AGENDA
Regular Hybrid Meeting
Town of Granby
Inland Wetlands and Watercourses Commission
Wednesday, July 9, 2025, at 7:00 pm
Town Hall Meeting Room

This letter is being submitted by Kimley-Horn & Associates, Inc. on behalf of AutoZone, Inc. ("Applicant") in response to the department review letters listed below:

AUTOZONE GRANBY

8 E GRANBY ROAD
GRANBY, CT 06035

SHEET 1 OF 1
1

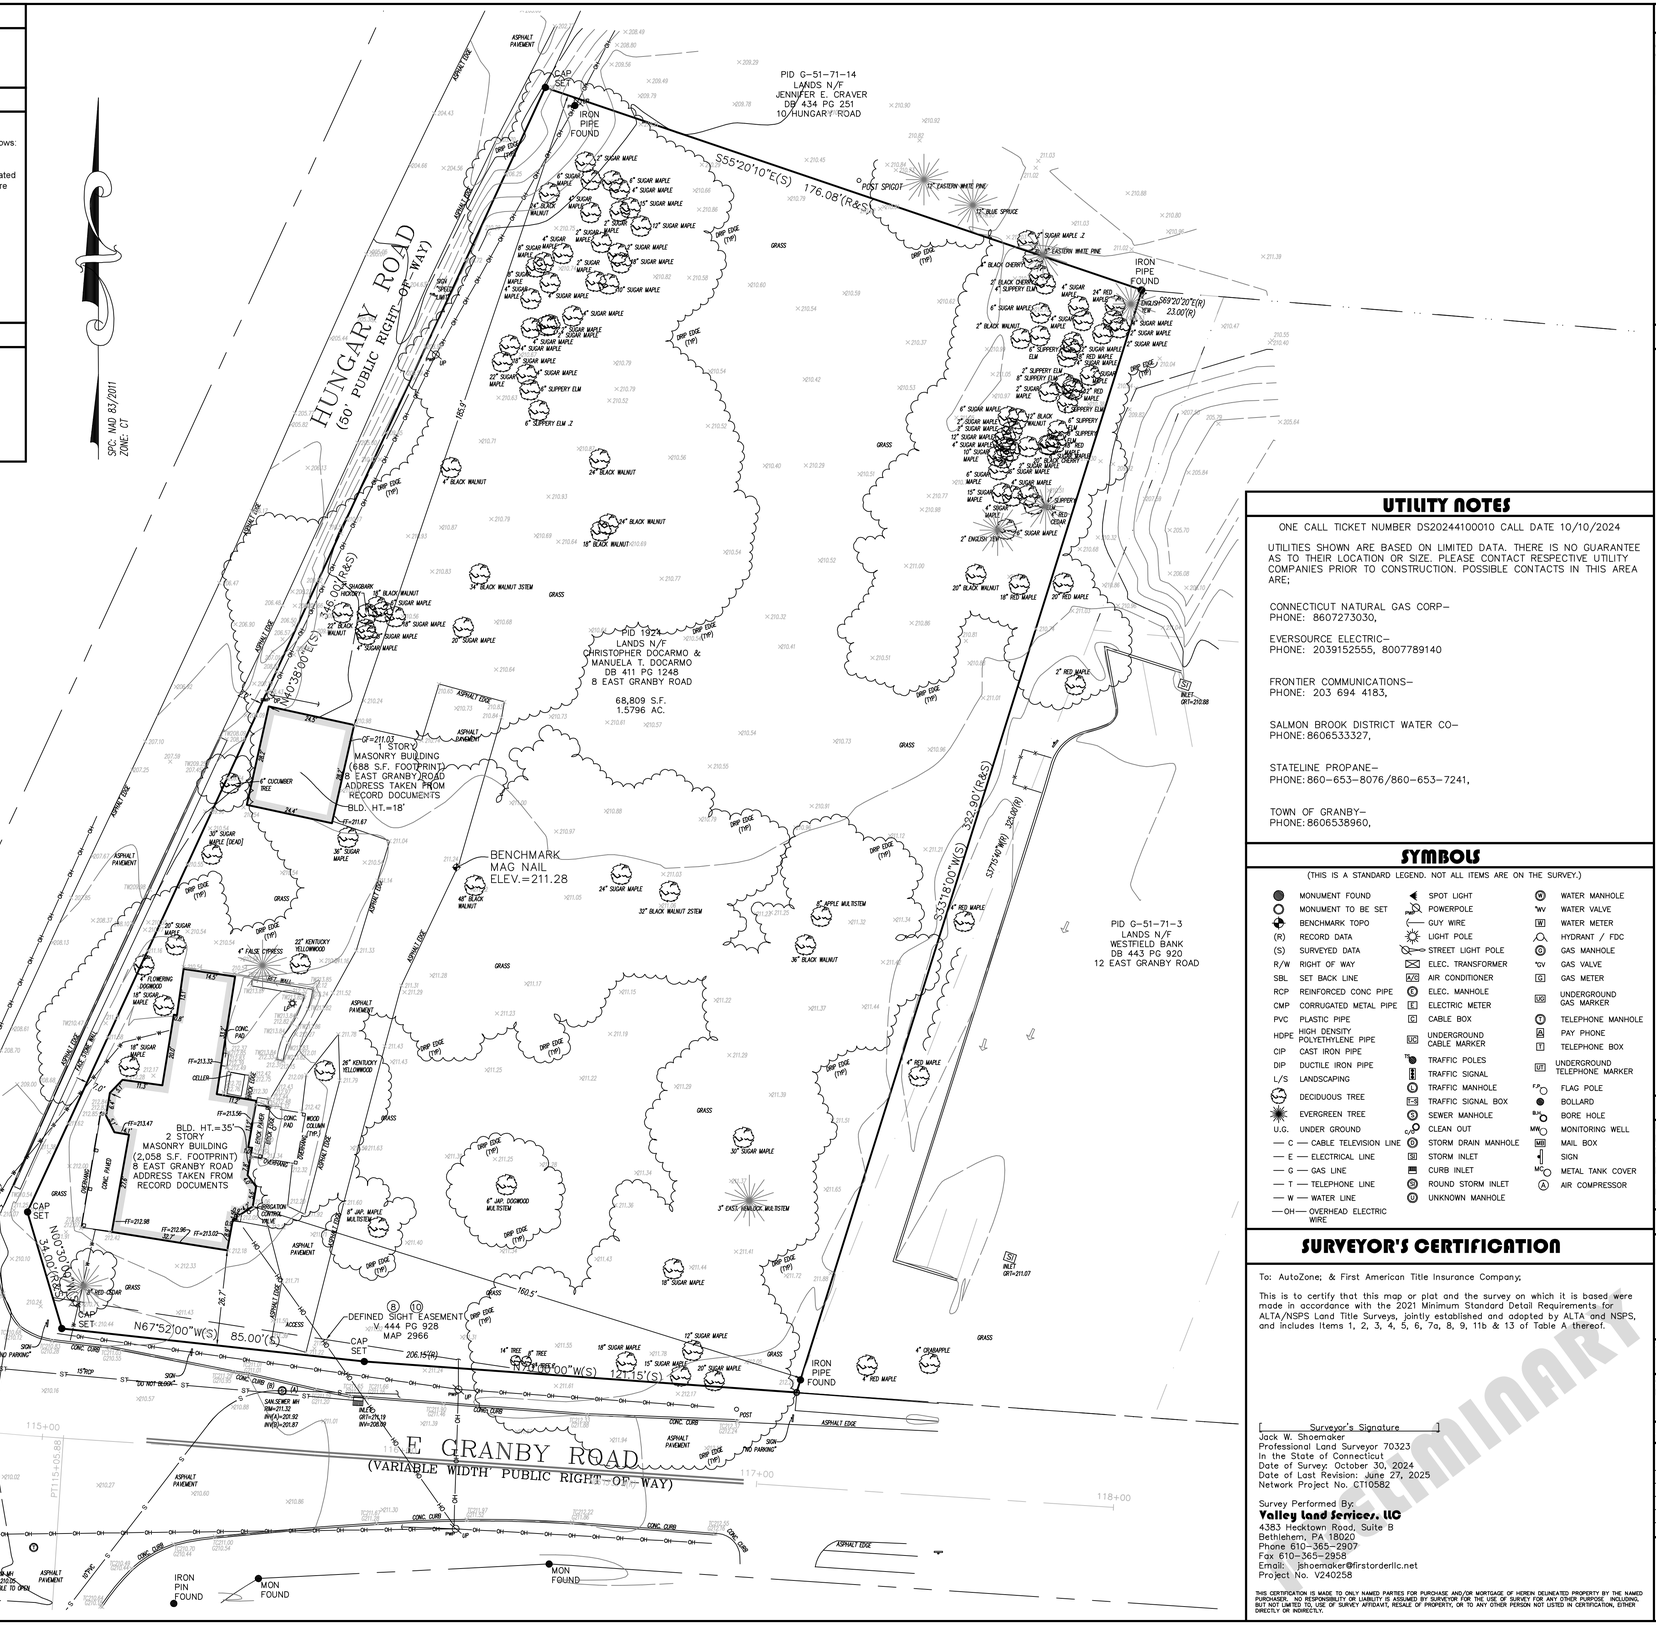
2. Show existing information easterly from site past the property line by about 20-feet.

3. For the trees to shown on the survey that are to remain, show their existing drip line.

5. The tree line shown on Sheet 1 of 1 the Site Survey and subsequent site plans shows the westerly tree line type indicating that the tree line is located to the east. It appears that this is intended to indicate that the tree line is located to the west, along Hungary Road. Please confirm.

Response: The survey has been revised to include the existing information east of the property approximately 20'.

Response: The survey has been revised to show all existing trees on the property and the existing drip line. The civil design sheets have been revised to show which trees are to remain and the remaining drip line.

Response: The survey has been revised to indicate the tree line along Hungary Road to be to the west. The civil plan set has been revised to match.

SHEET NUMBER
C-1.0

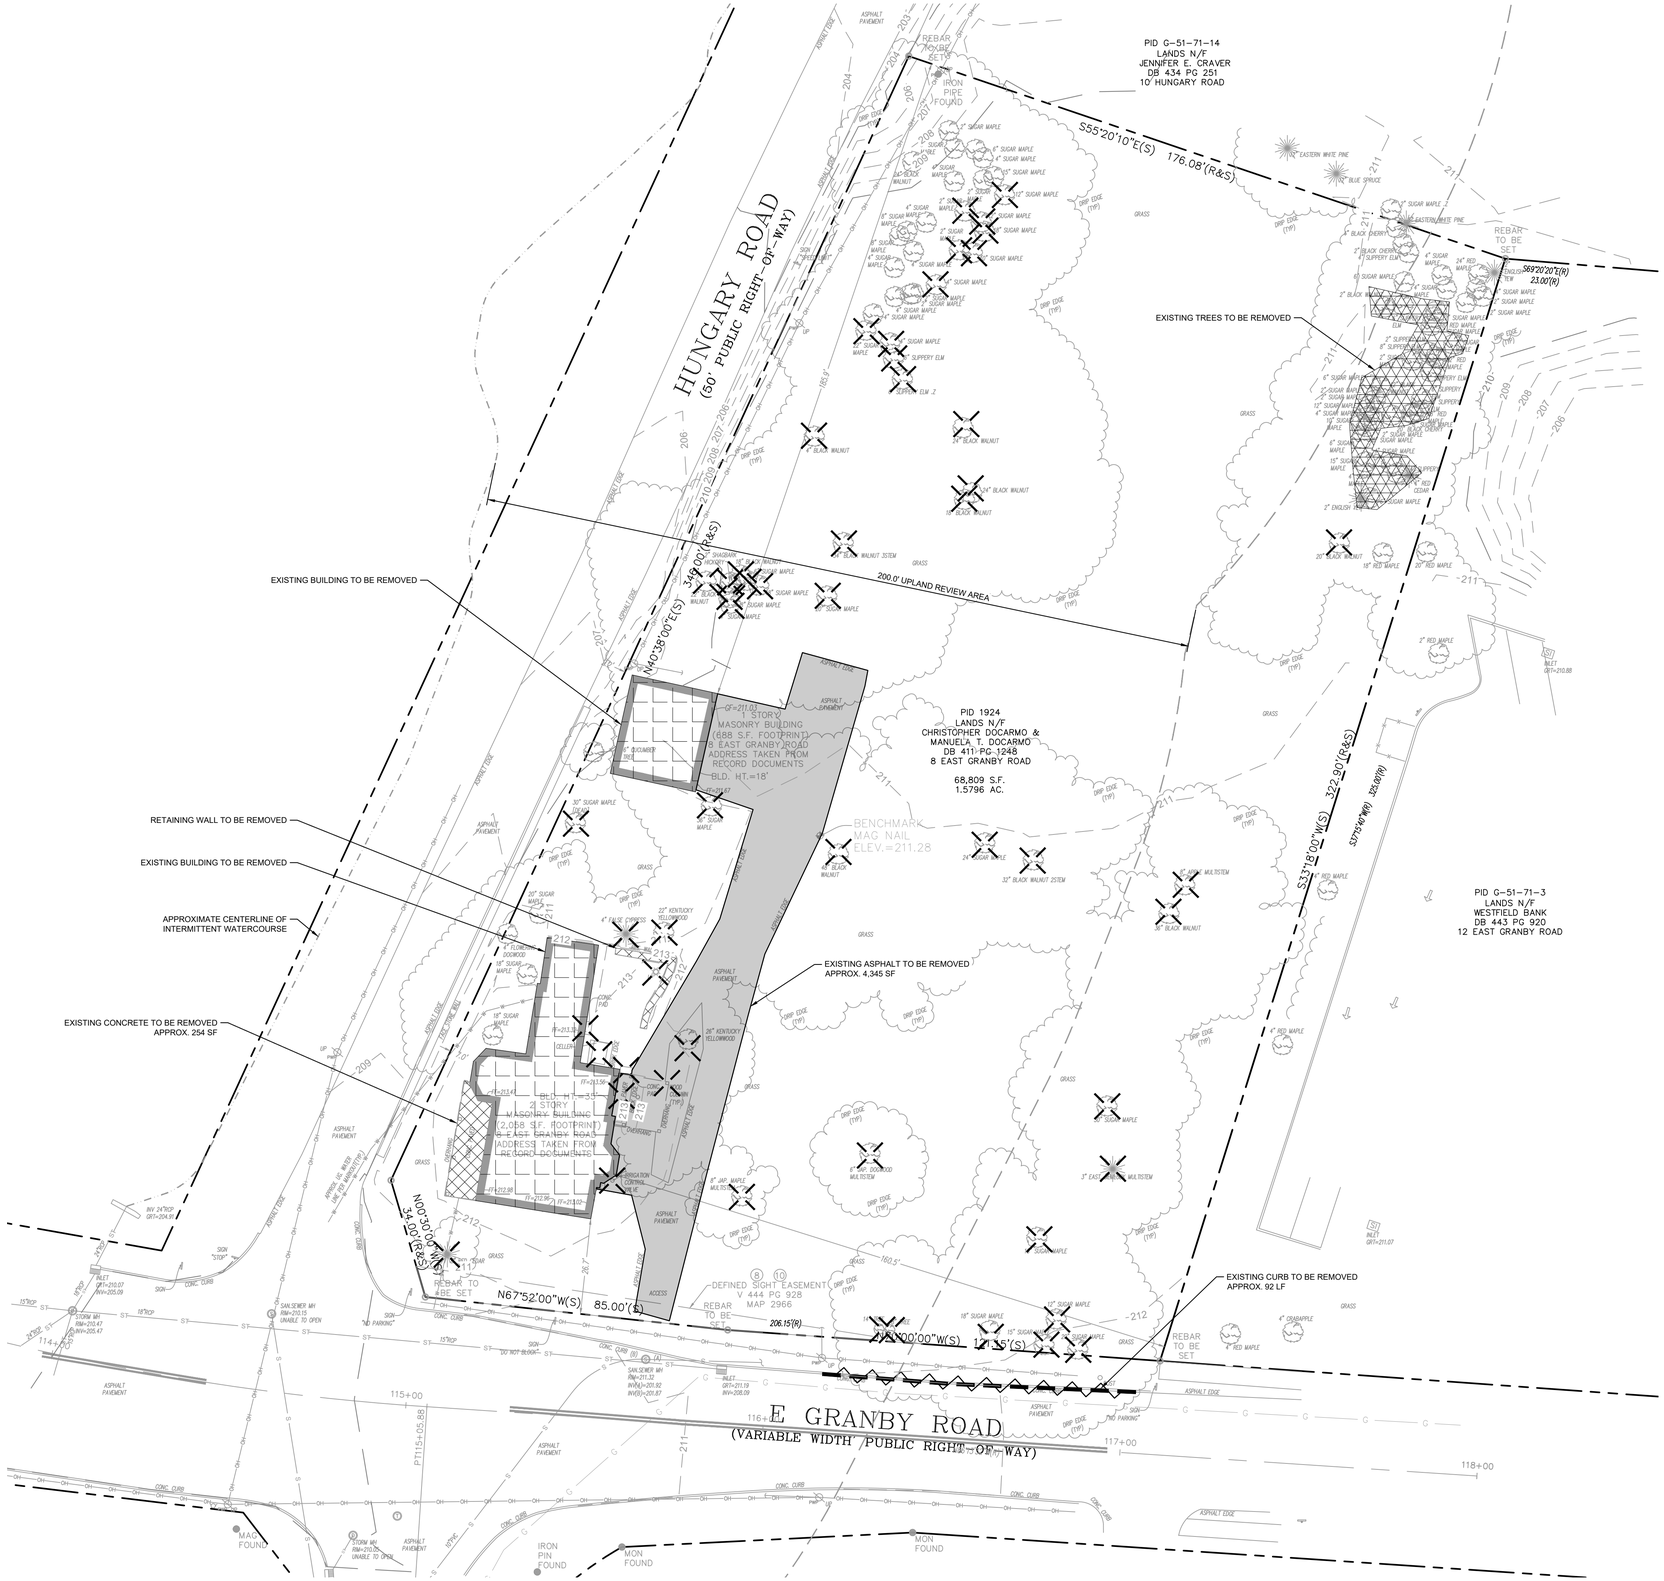
4. Please confirm and supply the reference to how the "Approximate Centerline of Intermittent Watercourse" shown on sheet C-1.0 has been determined.

Response: The centerline of the intermittent watercourse shown on Sheet C-1.0 was determined by as-builts provided by the Town of Granby and aerial imagery. Note 5 has been added to Sheet C-1.0 detailing the determination.

SHEET NUMBER
C-3.0

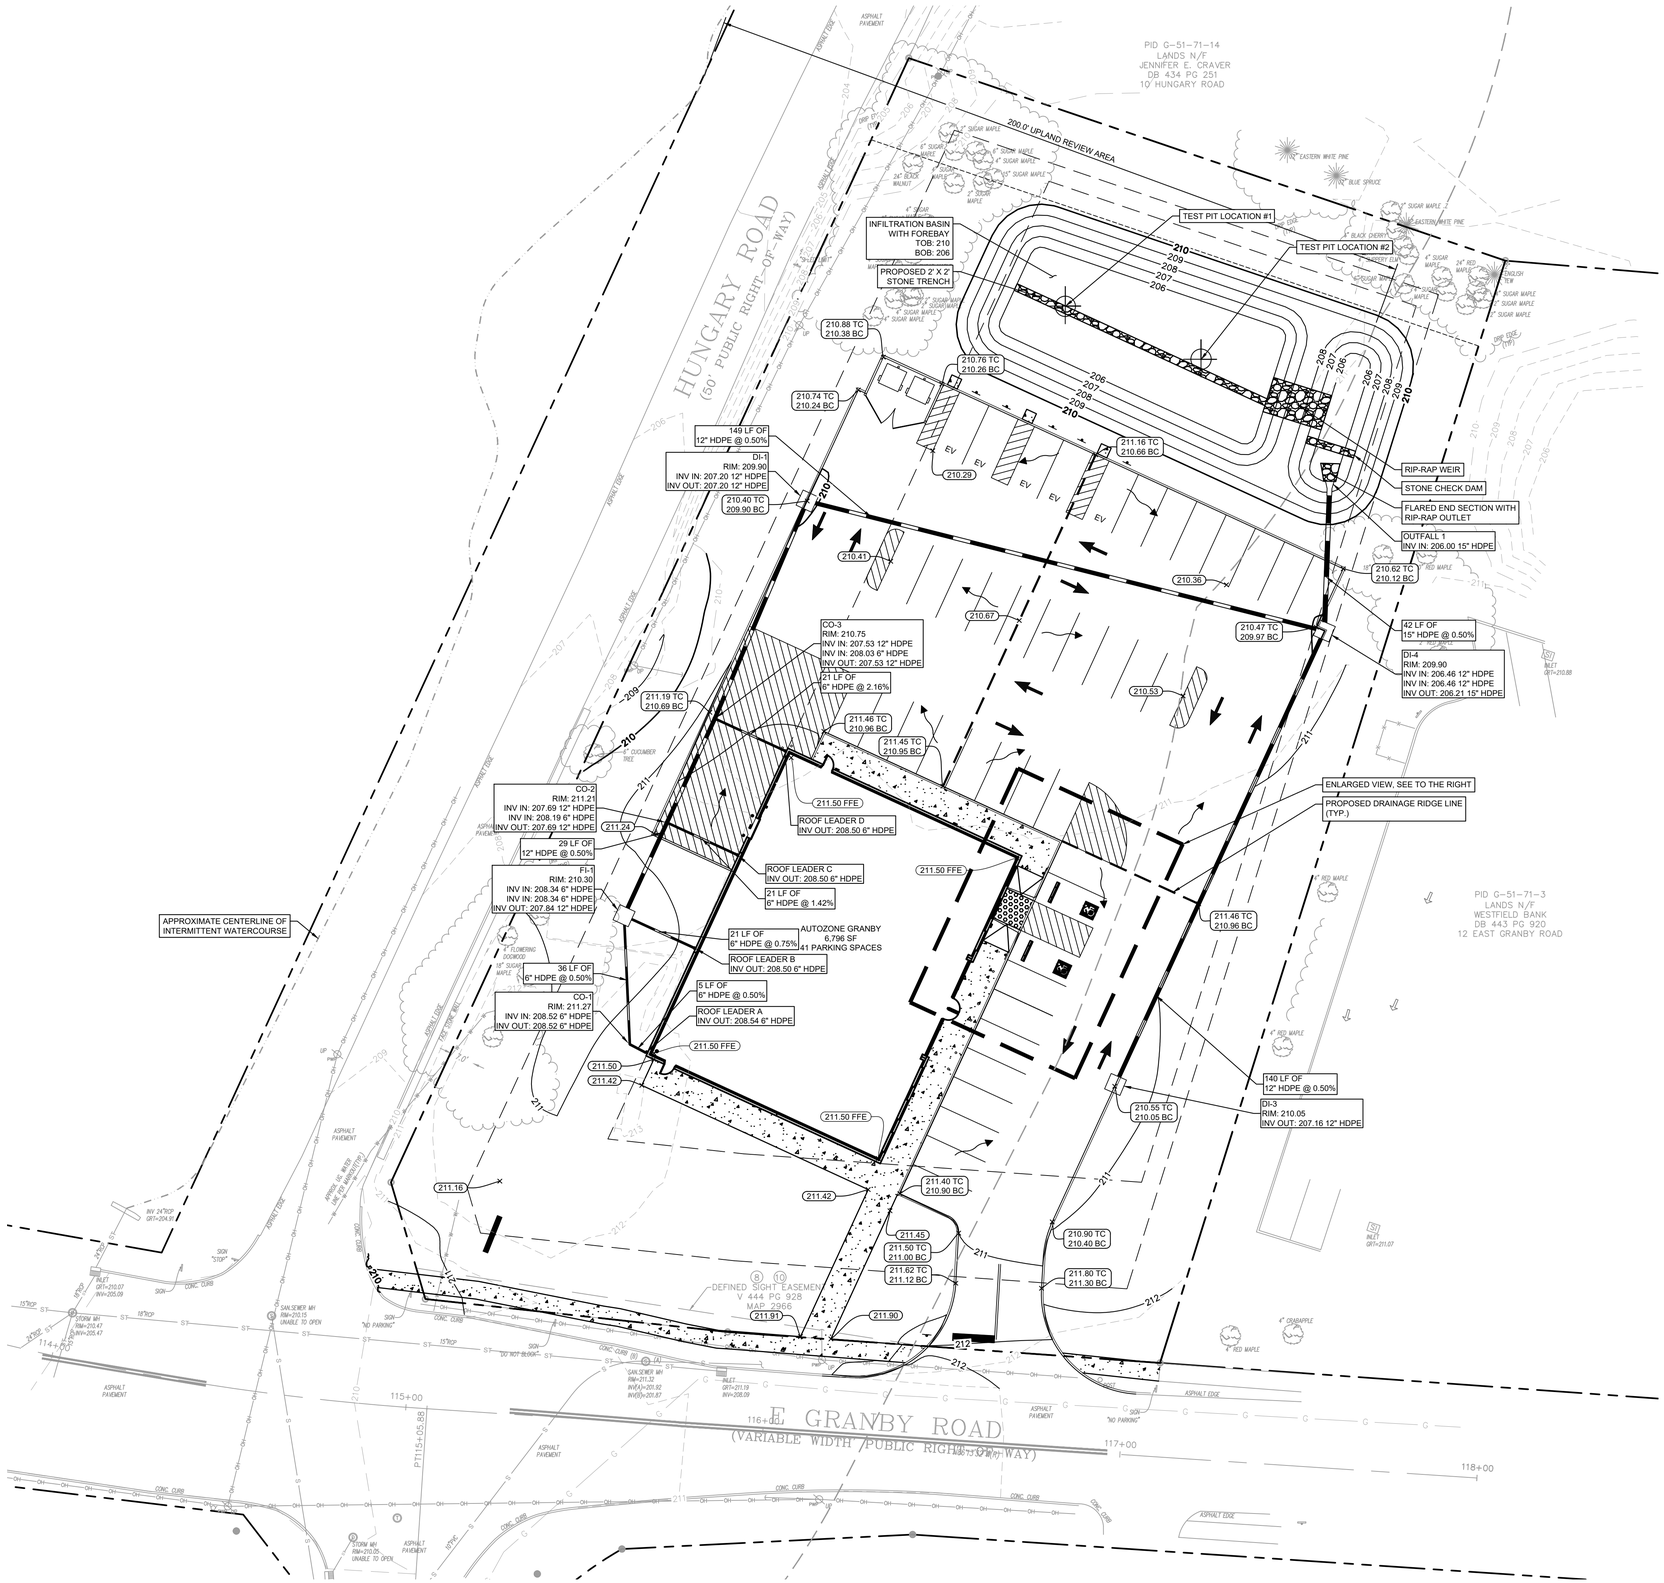
4. Add a stone trench at least 2-feet deep in the infiltration area to provide for infiltration during periods of frozen ground.

5. Show additional spot grades in the pavement areas to indicate how the pavement will drain.

17. At least two test pits are required in the proposed infiltration basin to support the design infiltration rate described on page 16 of the Stormwater Management Report. Add the test hole pit to the report and on sheet C-3.0. Test pits and soil data reporting to comply with the Connecticut Stormwater Quality Manual, March 30, 2024, Chapter 10, Test pits and Borings, pages 178 and 179. Refer design infiltration rate to table 10-2 and add it to the drainage report.

Response: The infiltration basin has been revised to include a 2' x 2' stone trench to promote infiltration during periods of frozen ground. A detail is of the stone trench is provided on Sheet C-6.1.

Response: Sheet C-3.0 has been revised to include additional spot grades, drainage ridge lines, and drainage flow lines to denote the drainage within the pavement area.

Response: Two test pits were completed on 6/24/25. The results have been added to the stormwater report and the locations are shown on C-3.0. An infiltration rate of 26 in/hr was observed, therefore, a design rate of 13 in/hr is utilized for the design calculations.

SHEET NUMBER
C-4.0

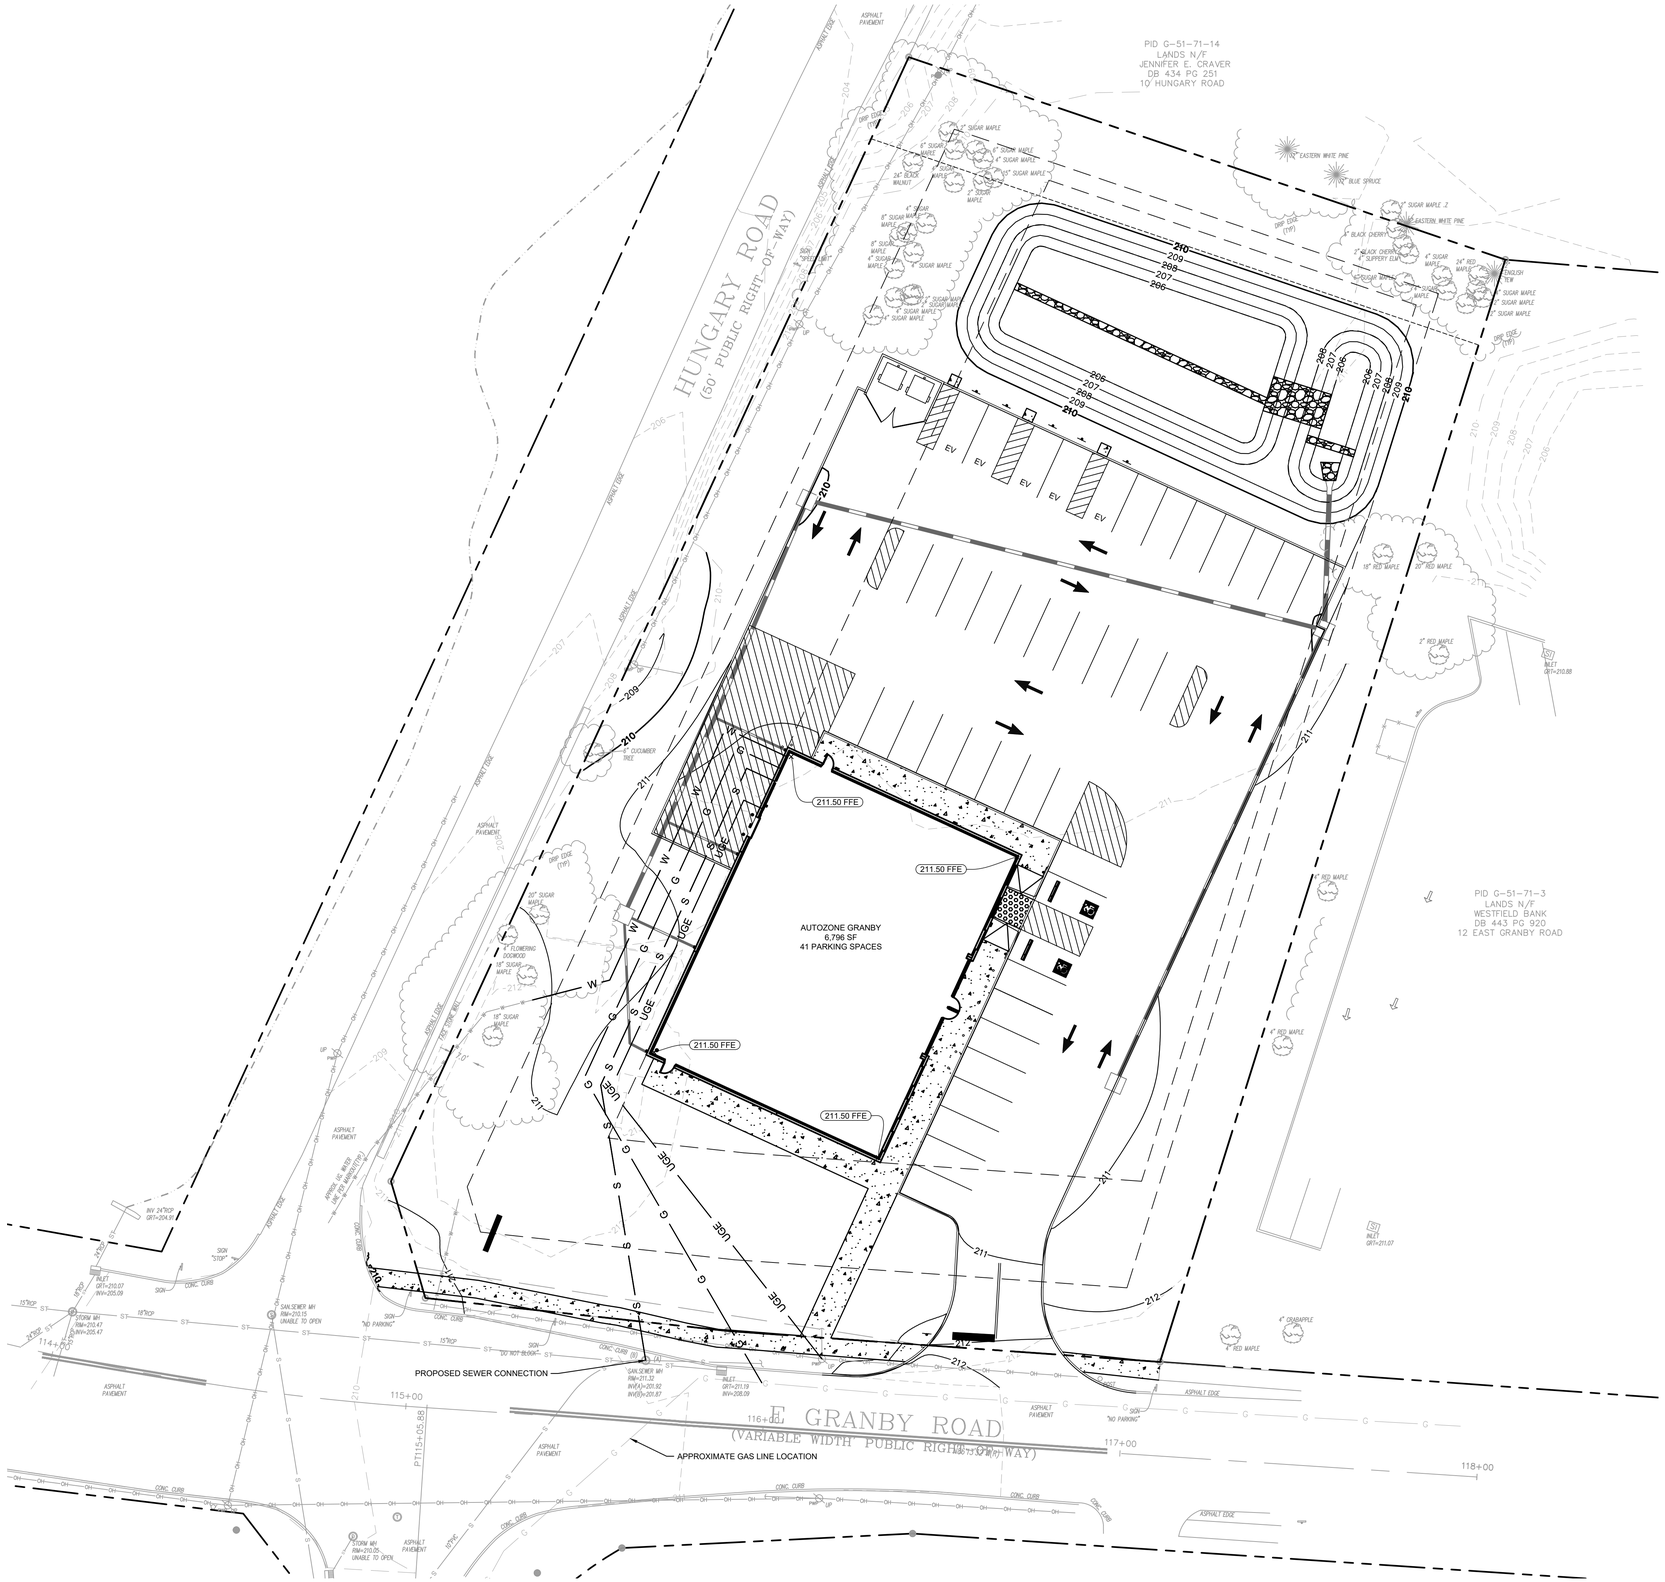
6. Show FFE.

7. Additional information (e.g. inverts, cleanouts, pipe length and slope, etc.) is required for the sanitary sewer connection. This is not needed for the wetlands application but will need to be shown on the site plan application plans.

Response: Sheet C-4.0 has been revised to include the FFE.

Response: Comment Acknowledged. Additional information regarding the sanitary sewer connection will be provided with the site plan application plans.
